RESOLUTION AFFIRMING THE DECISION OF THE HISTORIC
PRESERVATION COMMISSION

RE: 649 18th Street – Certificate of Appropriateness (Case # 20-2007-5.03)

Request from Edward C. Muelhaupt for the construction of a fence along the south property line at 649 18th Street located in the Sherman Hill Historic District. (20-2007-5.03)

CITY OF DES MOINES HISTORIC PRESERVATION COMMISSION
STAFF REPORT AND RECOMMENDATION
Wednesday, November 15, 2006

FENCE DESIGN SUBMITTED
WITH APPEAL 12/5/2006

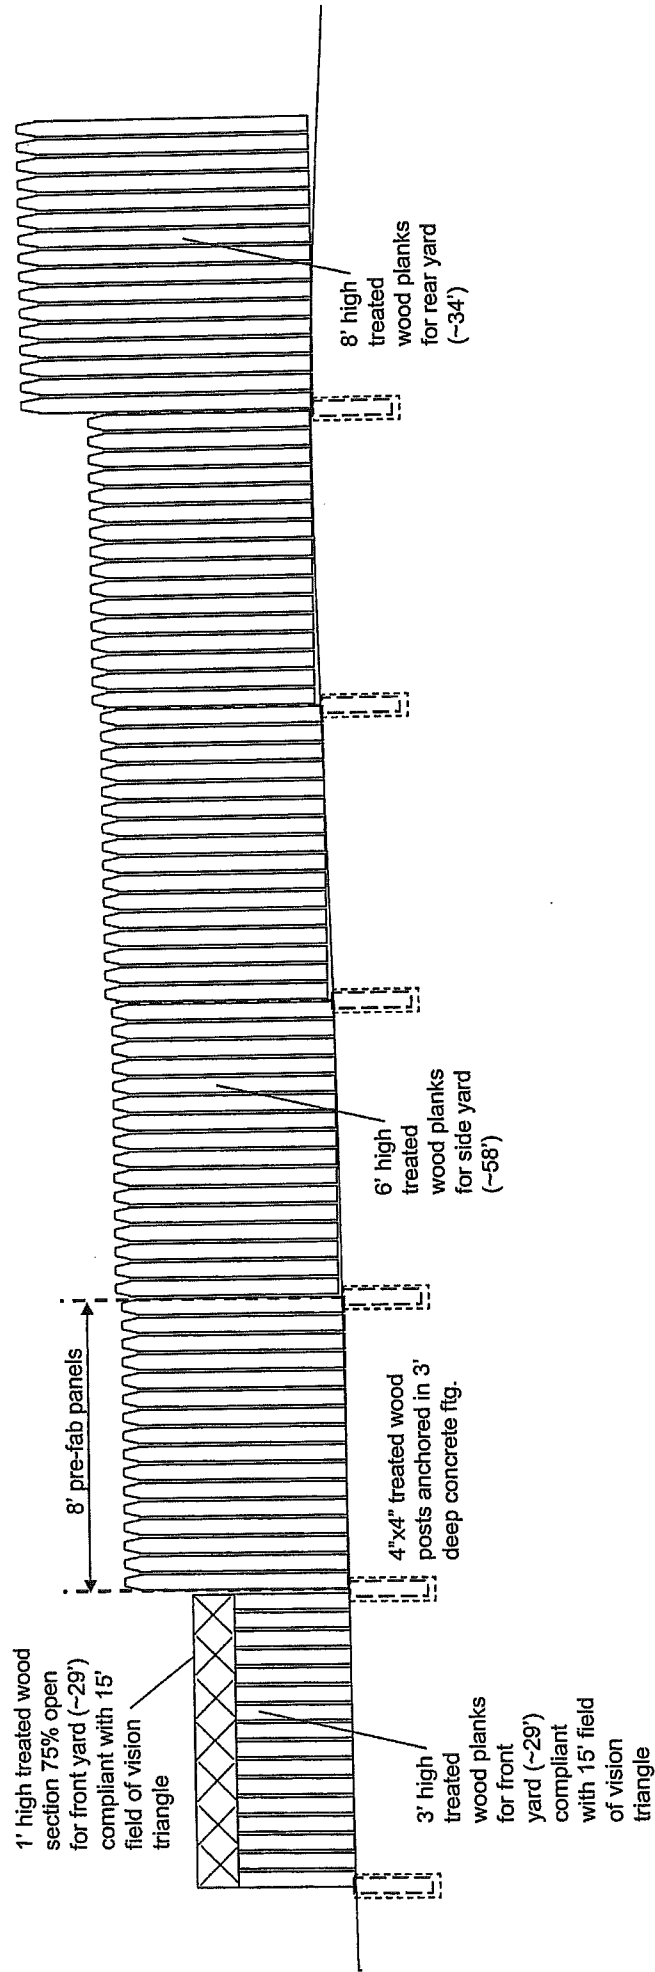
- Size of gaps
- Design of top
- Height in rear yard
- Exposure of posts
- Paint or stain required

The Historic Preservation Commission approved a motion that modified my proposed design for a privacy fence, although my proposal is aligned with the Des Moines ordinance for fences. My proposal for the design of the privacy fence is also consistent with existing fences in Sherman Hill with regard to all of the elements listed above. There are fences in Sherman Hill that have gaps smaller than 3/4", have dog ear shaped tops in the side and front yard, are taller than 6' in the rear yard, do not have exposed posts, and are not painted or stained. The special situation with an abnormally high volume and frequency of noise pollution coming from the Beacon of Life to the south of 649 18th Street is the primary reason the fence needs to be 8' in the rear yard. It is cost prohibitive to custom cut the tops of the fence boards as it would approximately triple the cost of the fence.

- The front yard segment of fence is limited to 3' in height with no lattice element on top of the pickets.
 - The rear and side yard segments of fence are limited to 6' in height.

- Pickets on both sides of the fence are placed back-to-back and not alternating.
 - Use of 4"x4" posts that are exposed and include a base and cap in the front and side yards.

- Post cap element may be similar in design to porch spindles.
 - Application of the same stain or paint finish on all sections of the fence.
 - Provision of a pointed top or other appropriate picket top design, not including "dog eared" style tops, along the entire length of the fence.

- Review and approval of post base and cap design and picket top design by staff.

FENCE DESIGN SUBMITTED
TO HPC 11/15/2006

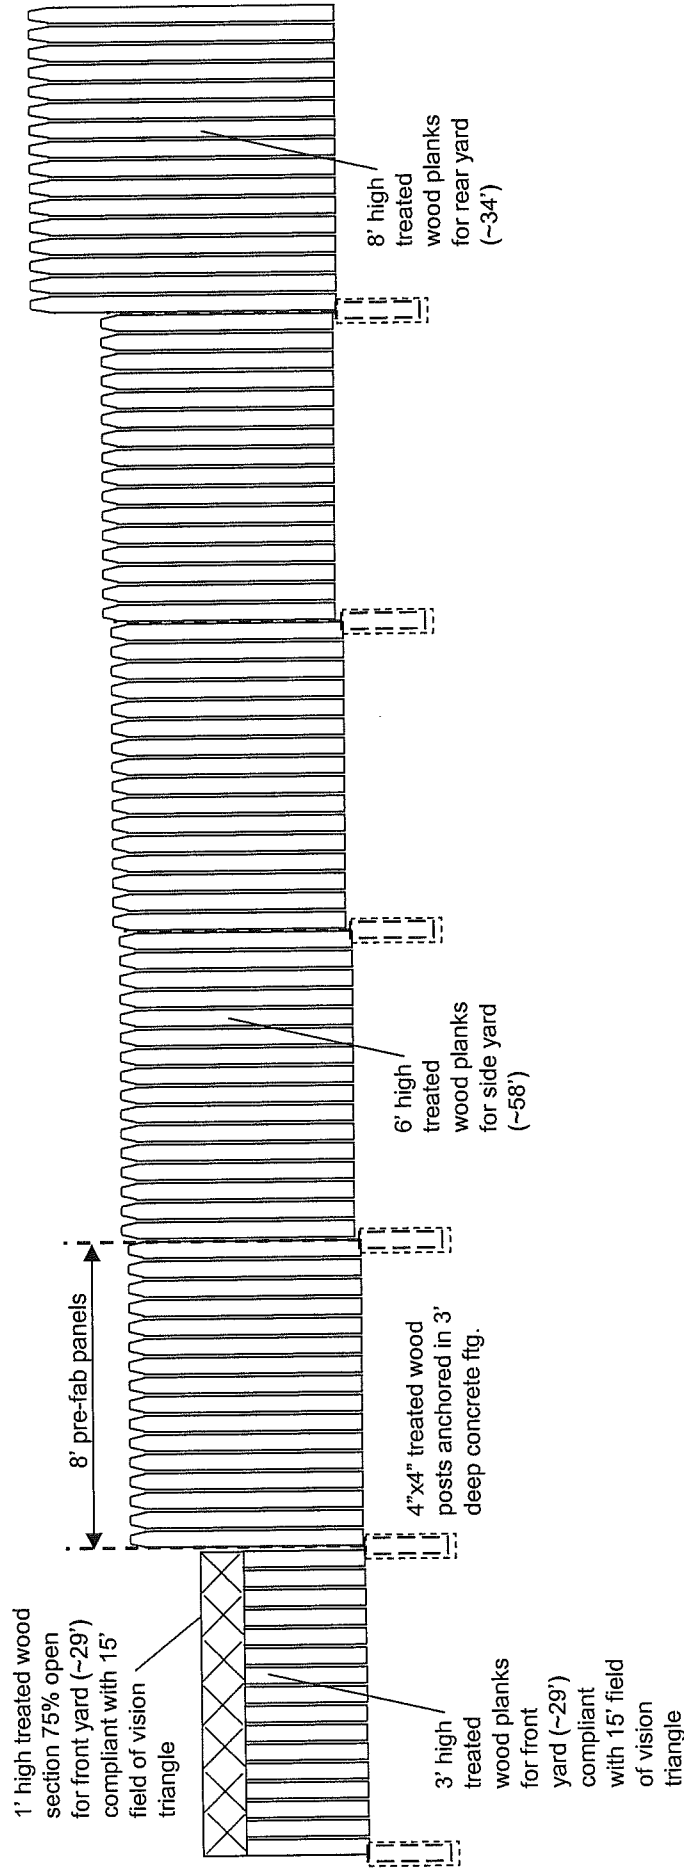
The proposed fence would consist of a 29'- long, 4'-tall section; a 58'-long, 6'-tall section; and a 34'-long, 8'-tall section. The proposed 8'-tall section does not meet this guideline. The Zoning Ordinance does allow fences to be 8' in height in the rear yard.

Staff believes that 8' is not appropriate in this case because the fence would sit on top of a retaining wall that is generally 4' in height. Staff recommends that the proposed 8'-tall section of fence be reduced to 6' in height.

The submitted drawing includes a note stating that the fence will include pickets on both sides of the fence. The pickets are prefabricated 8-long' panels. It is likely that they will naturally line up, however, staff recommends that meeting this guideline be a condition of approval.

The applicant is proposing 4" x 4" posts that are obscured from view by the pickets. These guidelines indicate that posts should be exposed and should

include a base and cap in the front and side yards. Staff recommends meeting these guidelines be a condition of approval.

The proposed pickets are $\frac{1}{2}$ " thick and $5\frac{1}{2}$ " wide with a dog-eared style top. The pickets of the front yard section of the fence have a flat top with a 1'-tall section of lattice above. The Zoning Ordinance (Sec 134-1296) limits the height of fences in the front yard to 3' or 4' if the entire fence or the top 1' of the fence is 75% open.

The thickness and width of the pickets meet these guidelines but the style of the pickets do not. These guidelines indicate that dog-eared fences are acceptable in rear yards only. Staff also believes that the use of lattice to extend the height of a fence in the front yard is not appropriate. Staff believes the intent of the guideline that allows lattice to be used above pickets is for side and rear yards, which are generally thought as the private portions of the yard and are less visible from the street.

Staff recommends that the provision of pointed-top pickets or another appropriate picket design be provided in the front, side, and rear yards. This will provide design consistence along the entire length of the fence.

The submitted drawing indicates that a limited amount of space would be provided between the pickets. Staff recommends that the provision of a $\frac{3}{4}$ " gap between the pickets be a condition of approval to ensure compliance with the guidelines.

The submitted information indicates that the fence would be constructed of treated wood but does not indicate if the fence would be painted. Staff believes that all section of the fence should be painted, stained or left exposed for consistency.

1. The fence in the rear and side yards is limited to 6' in height.
2. Pickets on both sides of the fence are place back-to-back and not alternating.
3. Posts are exposed and include a base and cap in the front and side yards.
4. Provision of a ¾" gap between the pickets.
5. Application of the same finish on all sections of the fence.
